**Capital School District
Central Middle School
Interior Renovations
211 Delaware Ave. Dover Delaware 19901
Bid Pac E– Contracts 1 thru 10
October 7, 2024**

Addendum No. 1

ADDENDUM 1

PROJECT: Central Middle to Elementary School Interior Renovation

2 FIRST FLOOR ELECTRICAL LIGHTING PLAN - AREA E
SCALE: 1/8" = 1'-0"

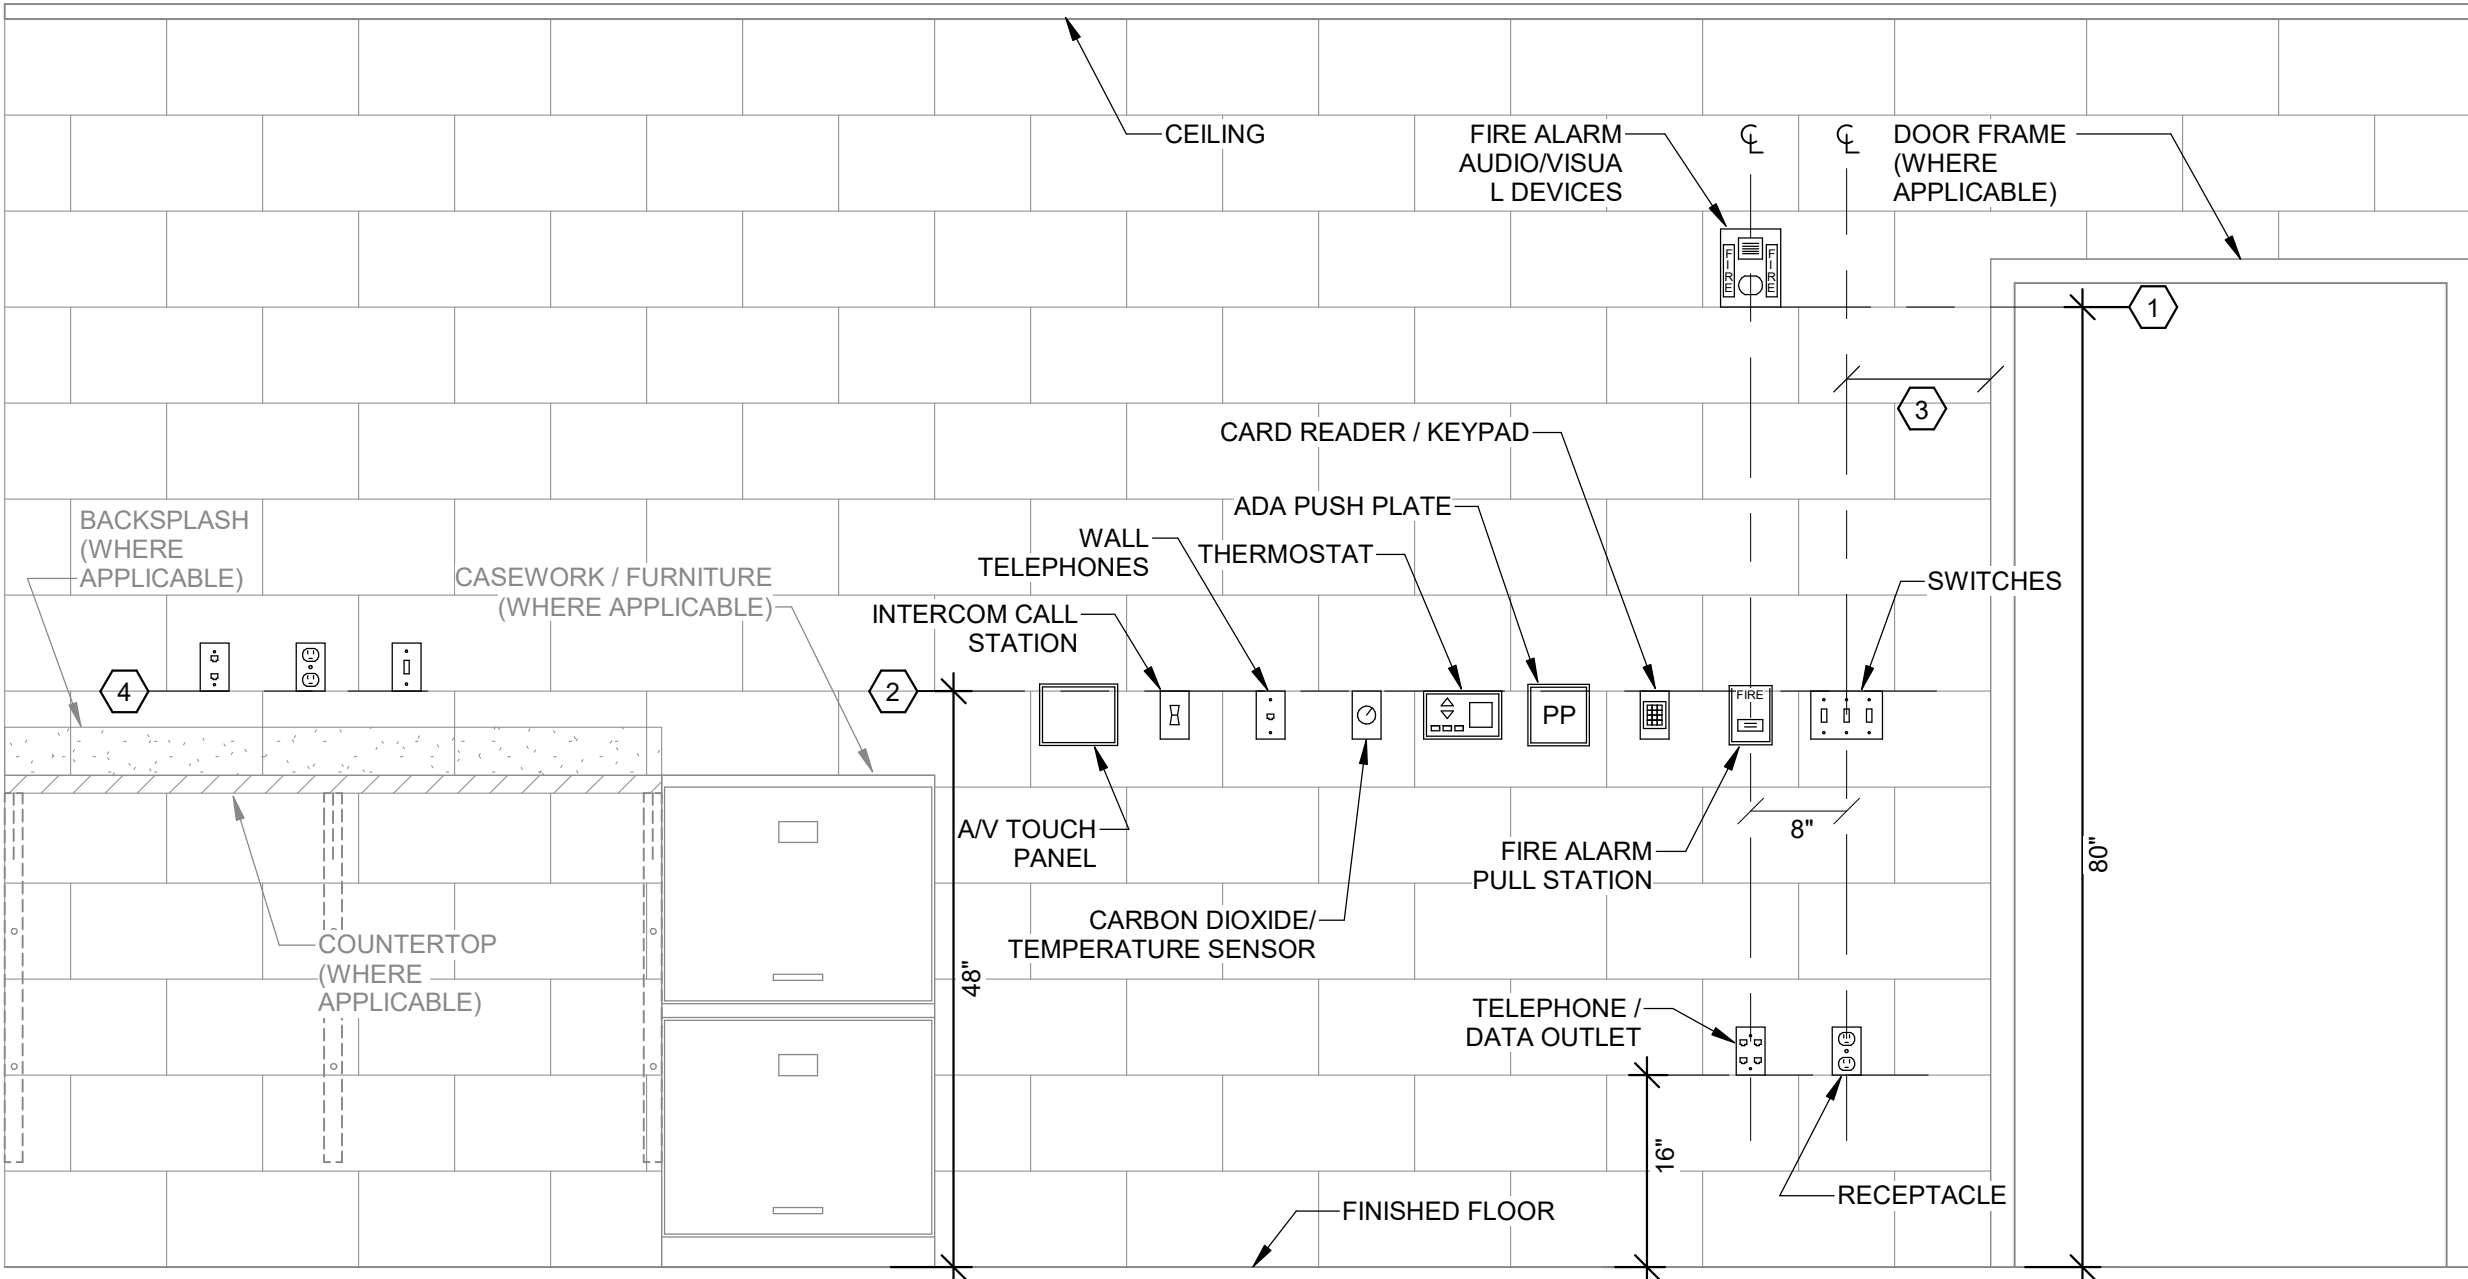
7. E-201D/E – FIRST FLOOR ELECTRICAL LIGHTING PLAN – AREA D/E

- a. **REVISE** lights in grid in Office D112A.
